GJS Plot F, Manchester

Tower F2 - Podium Design | 26.04.2024

F2-SHP-A180-RP-XX-B5D803 | P04

Background to the report

View 1: Elevation PS1 - Great Jackson Street

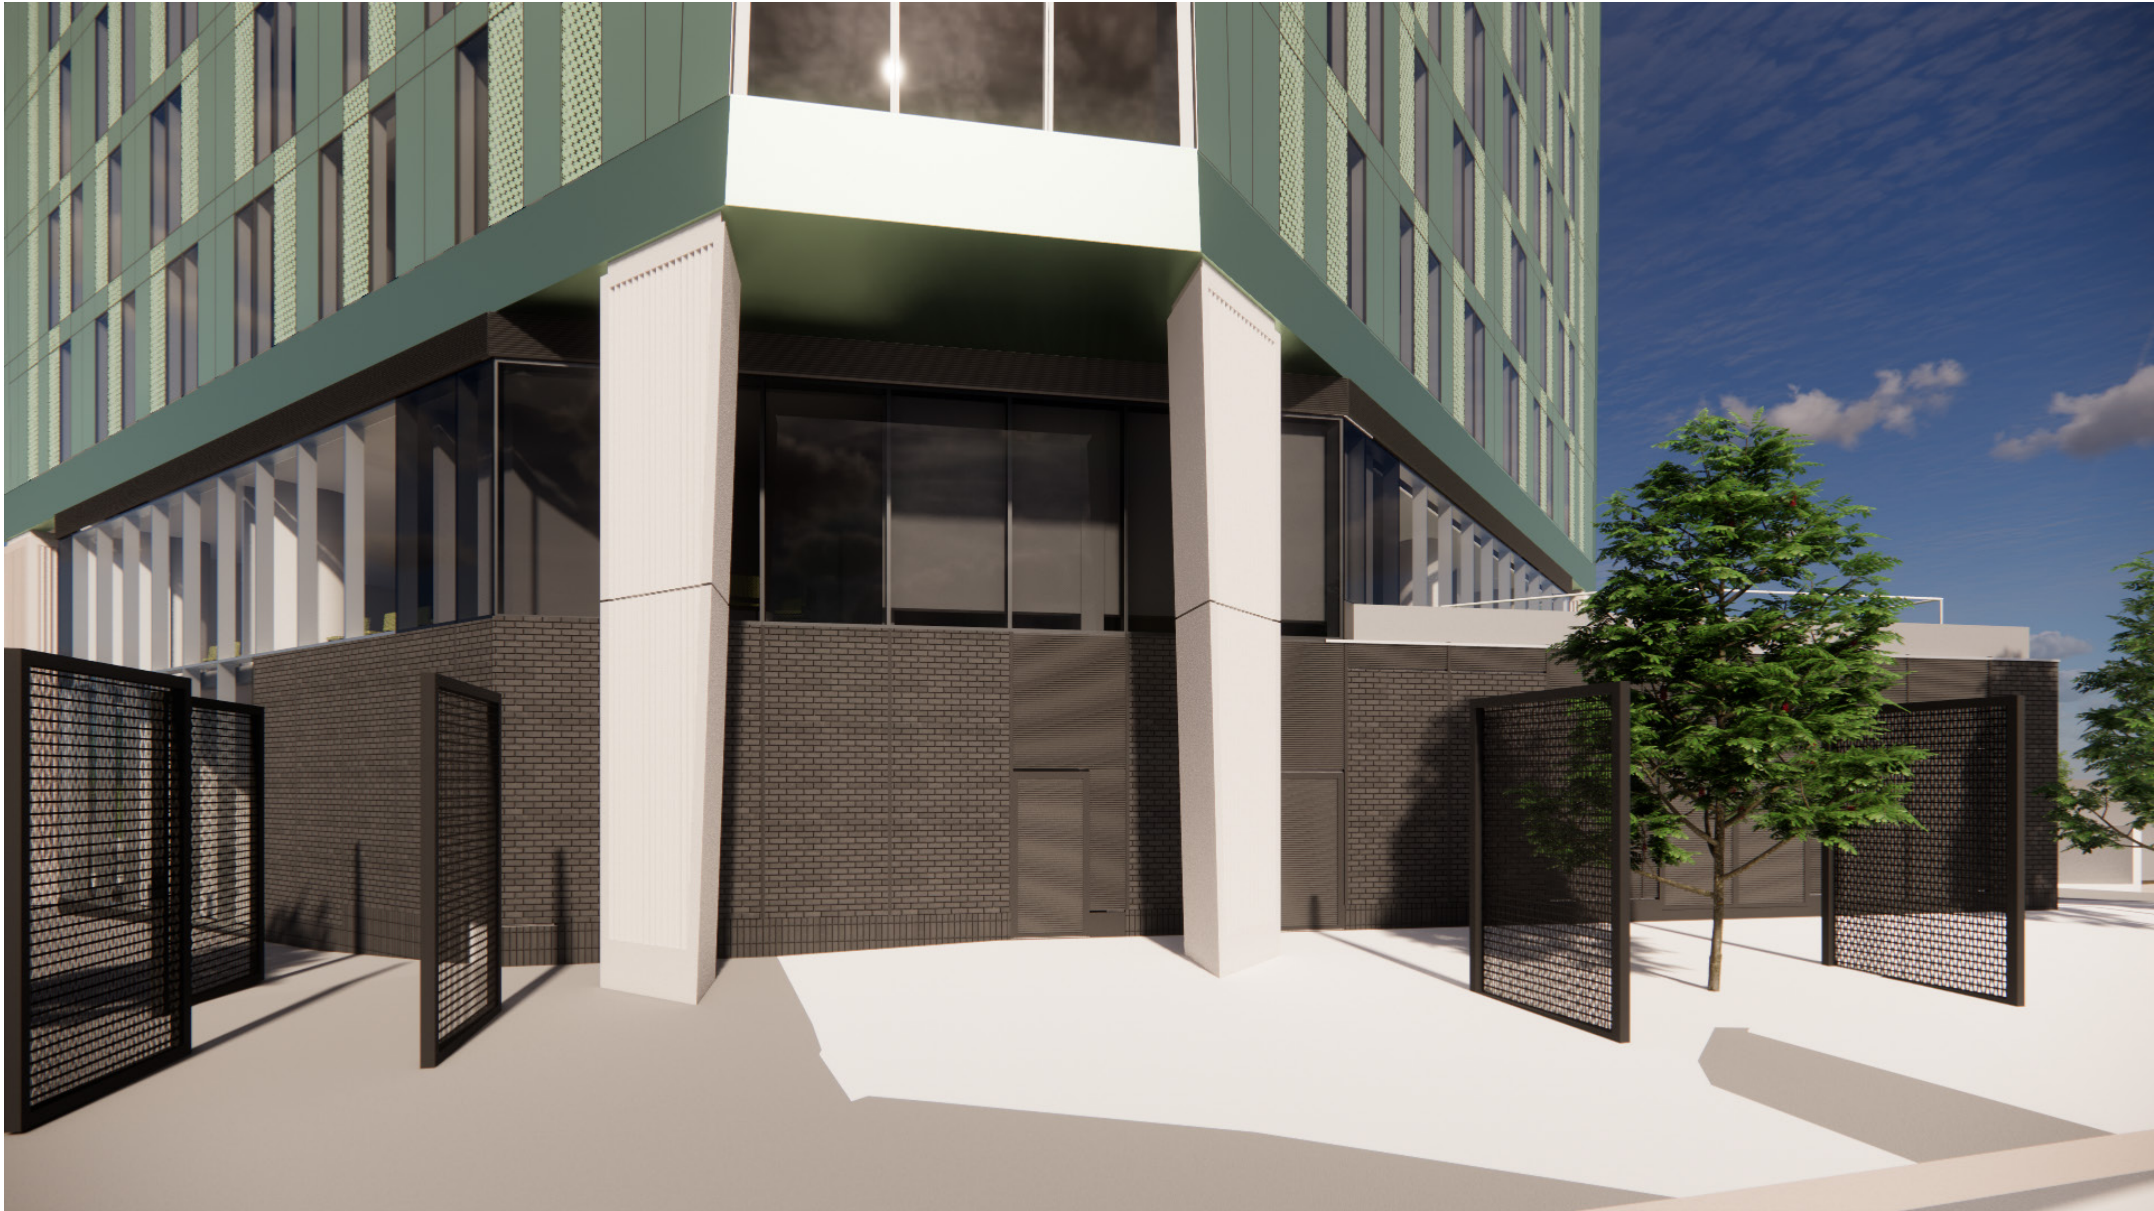
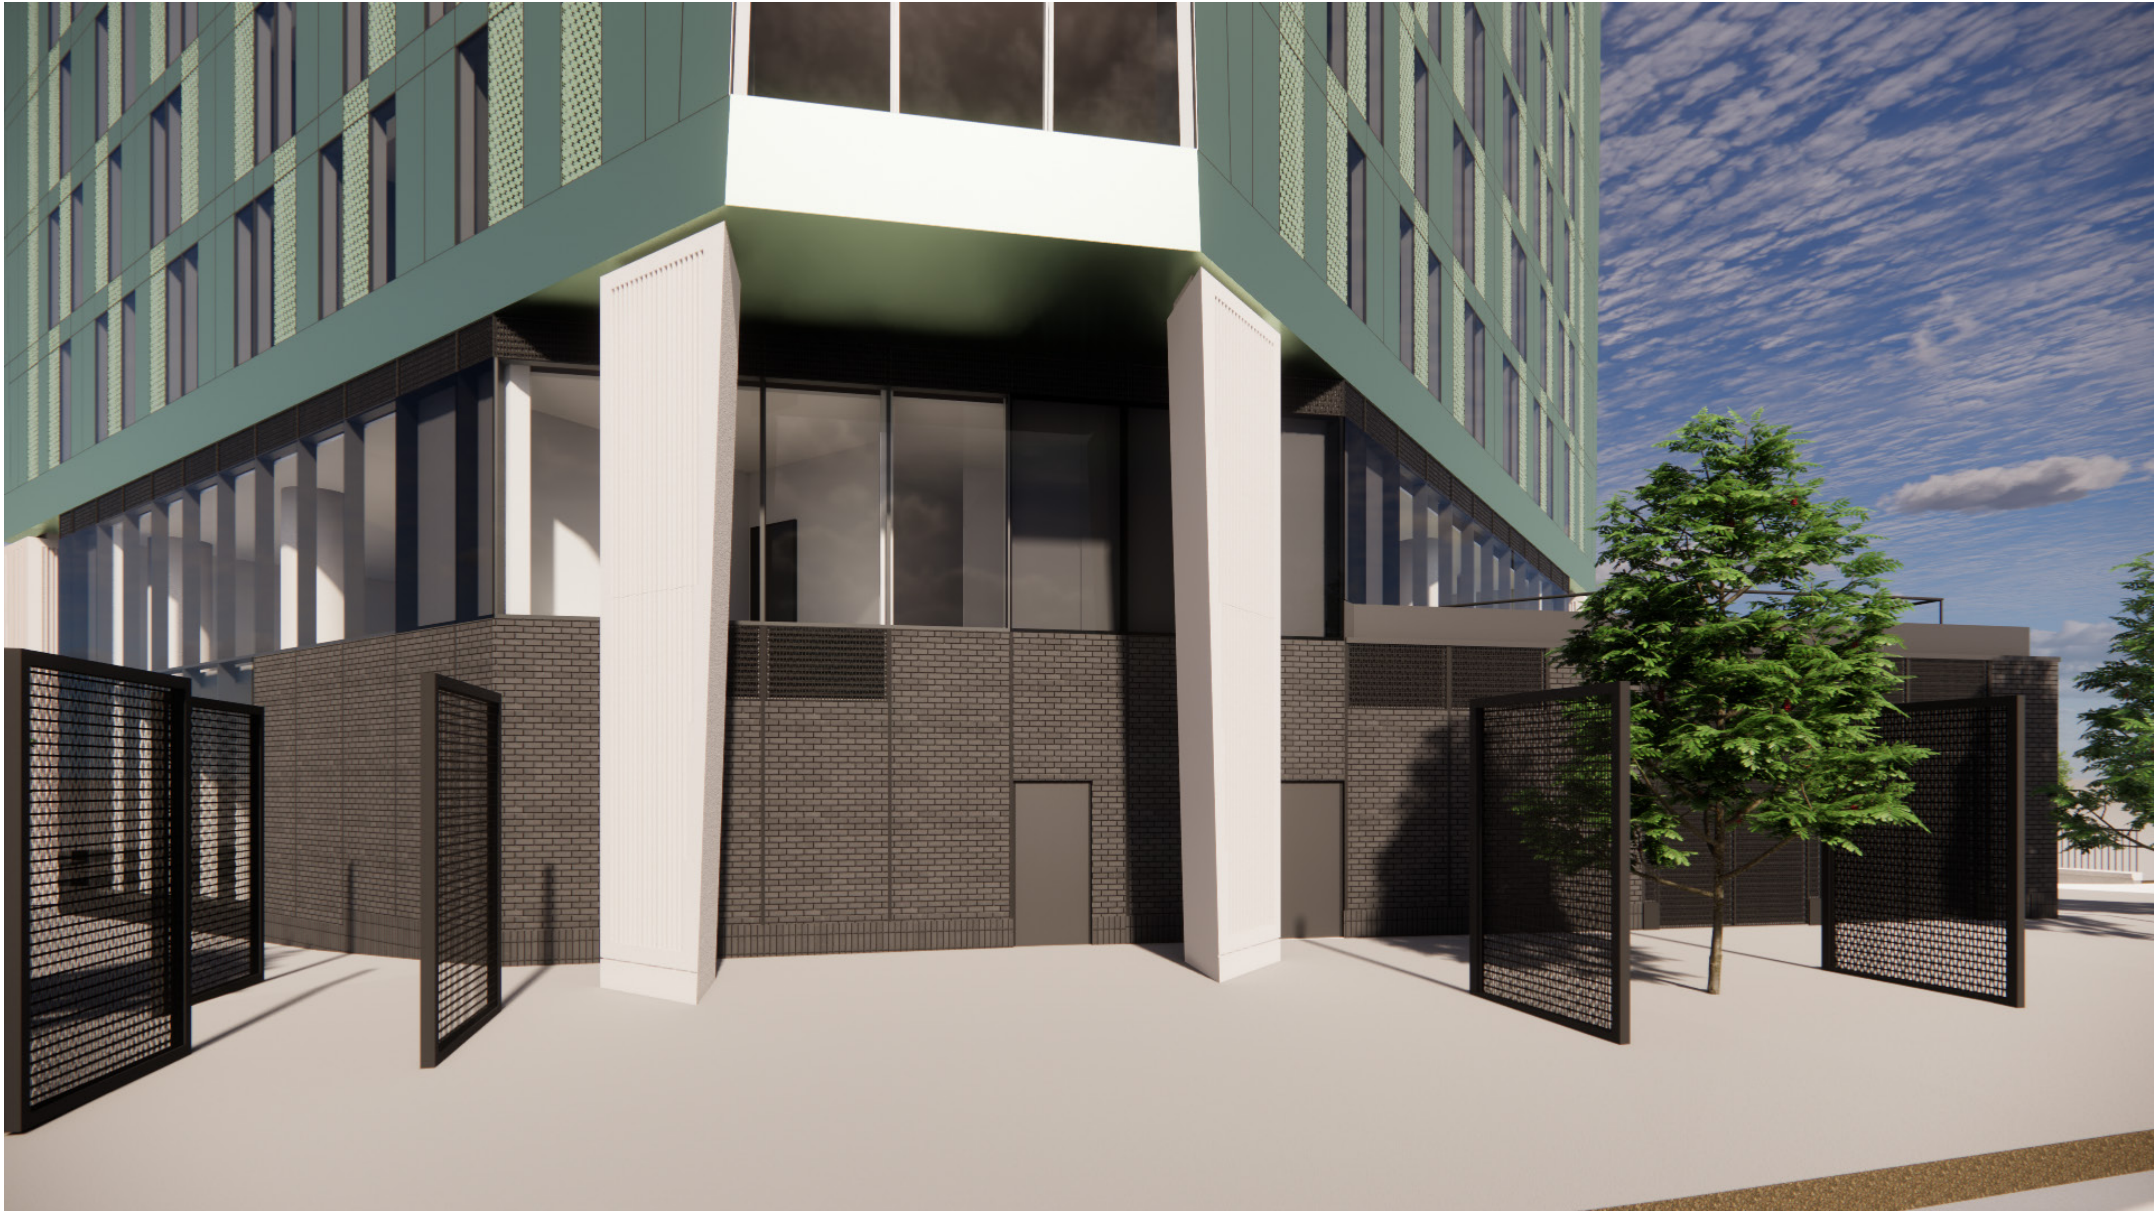
Updated Proposal - Decorative Screens

View 2: Elevation PS1 - Great Jackson Street

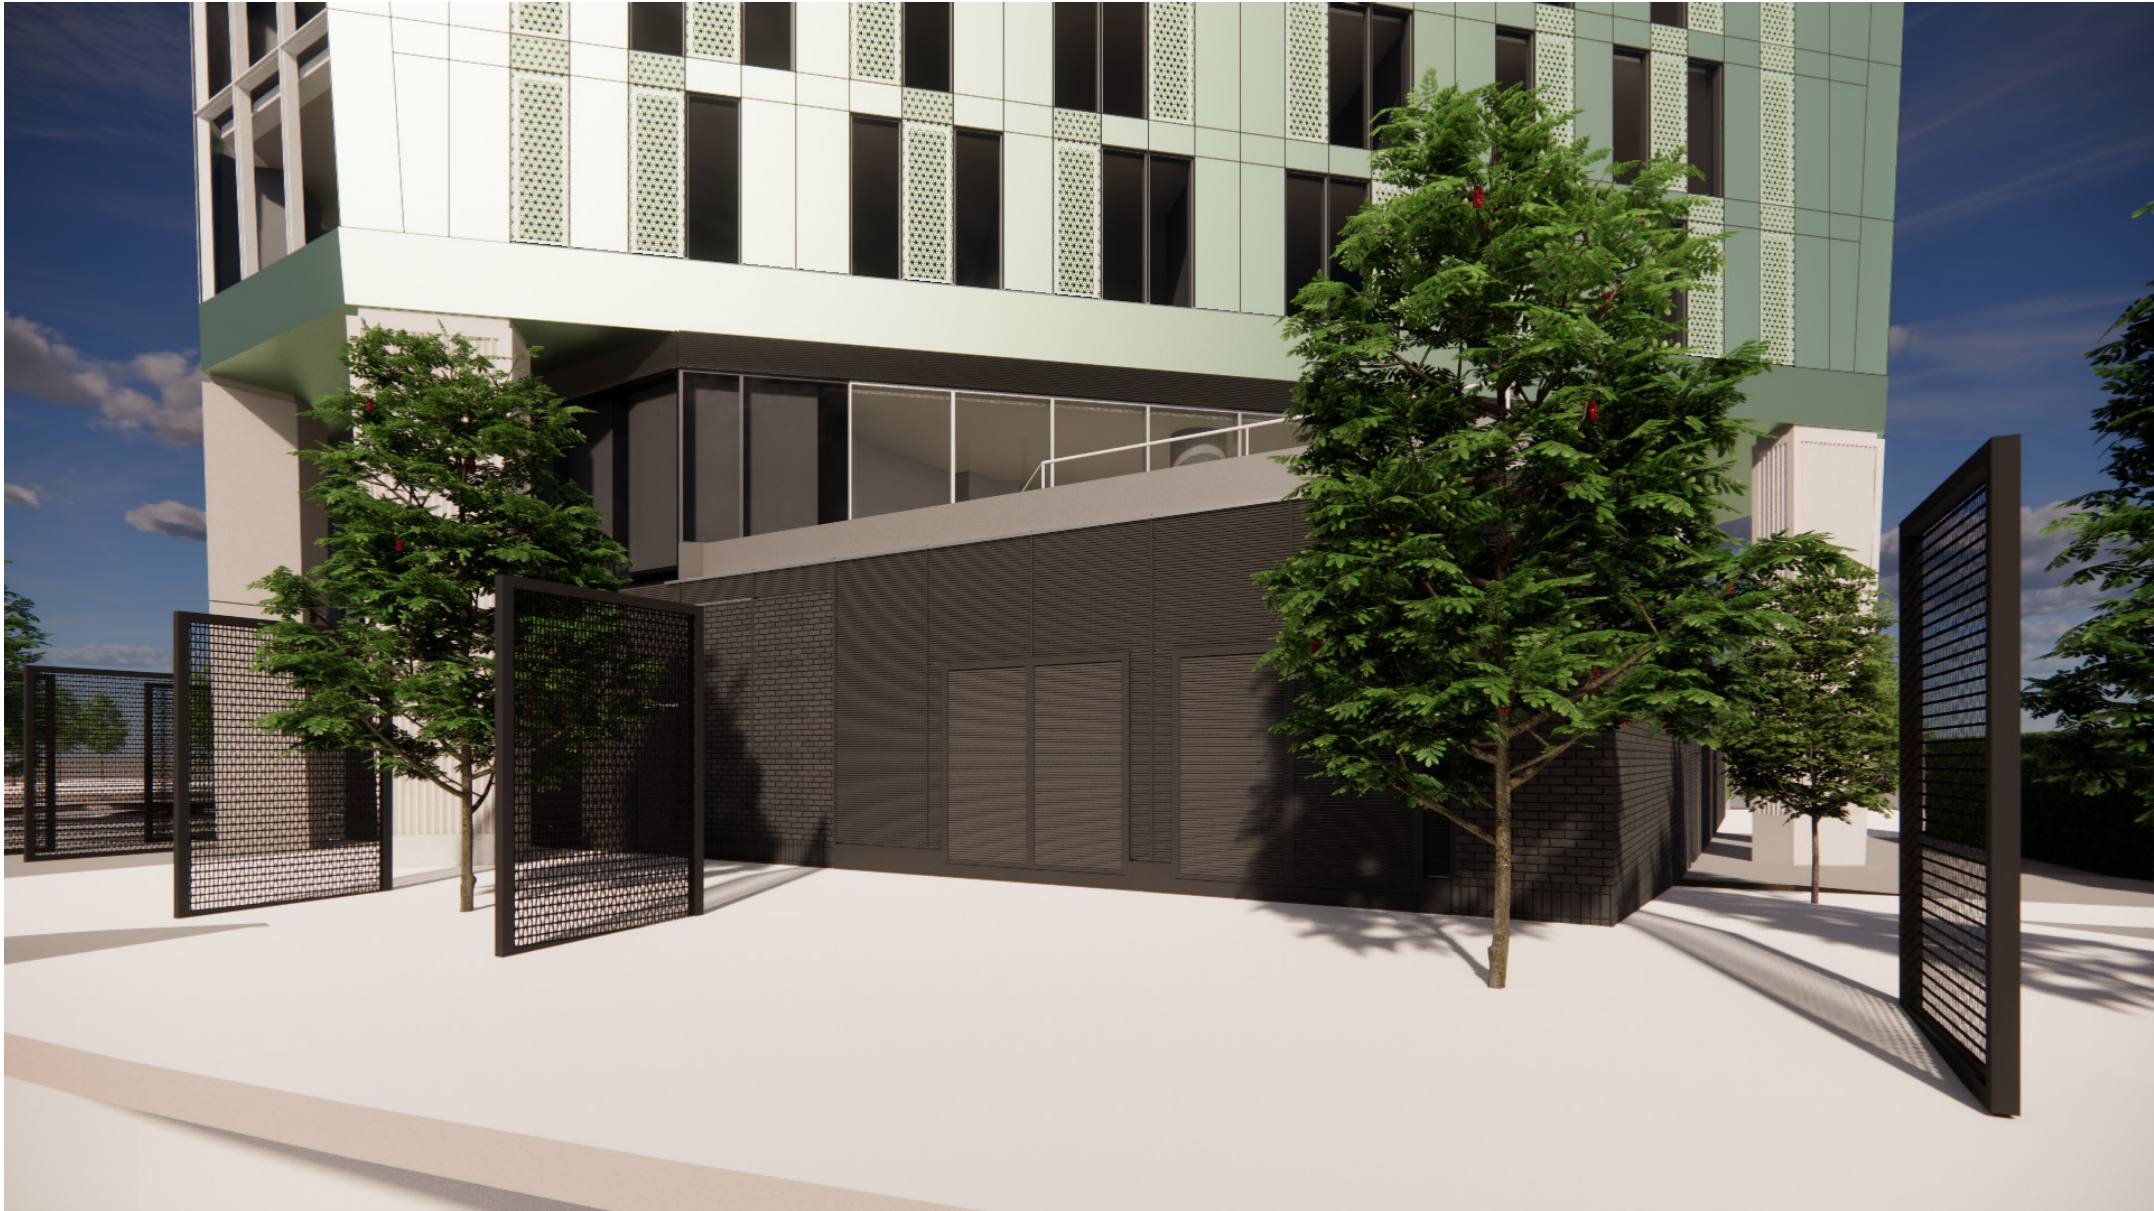
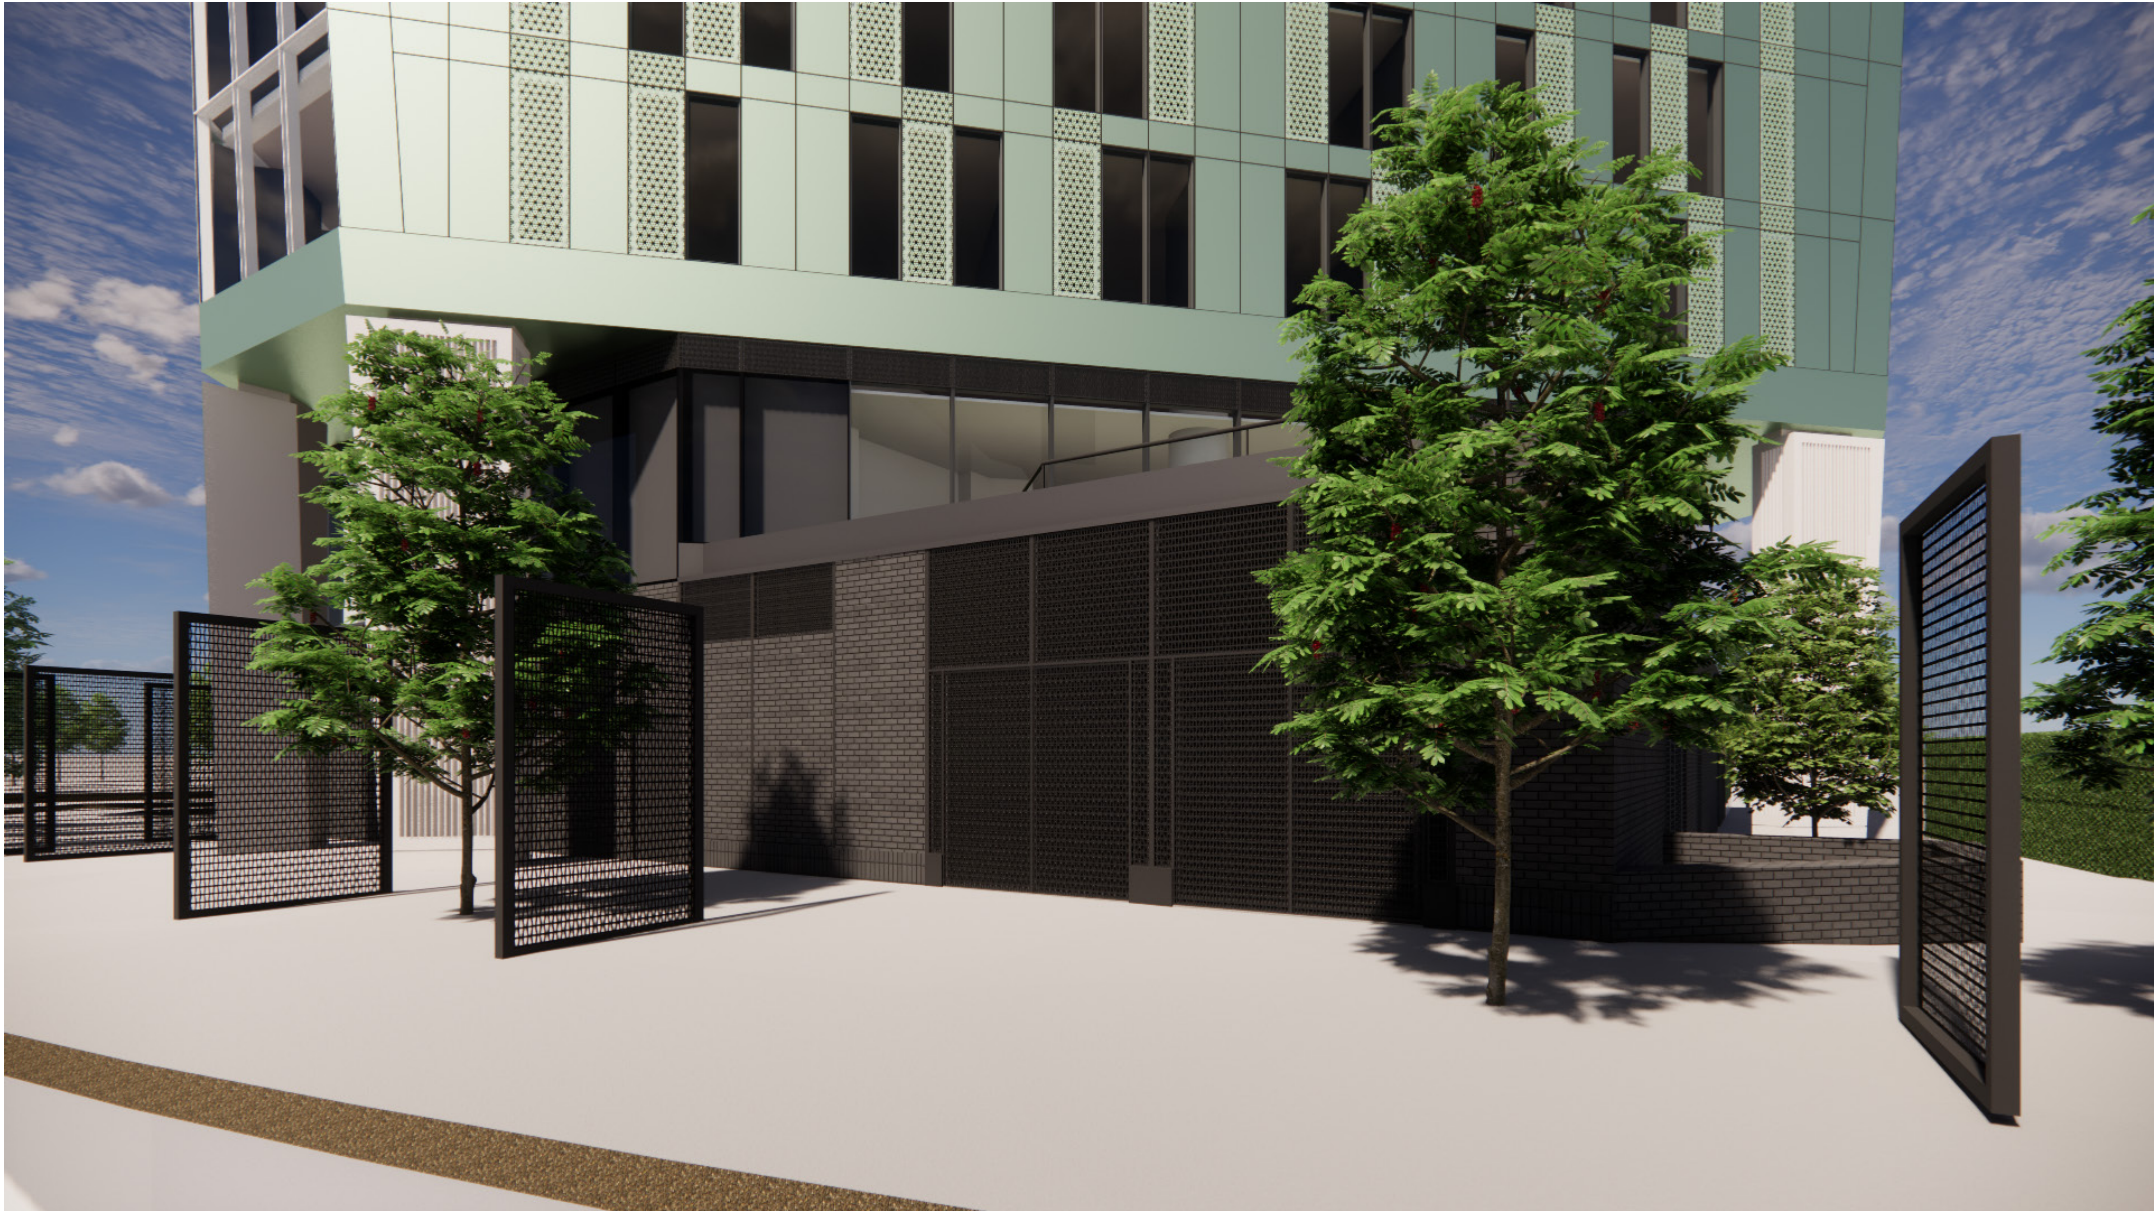
Updated Proposal - Decorative Screens
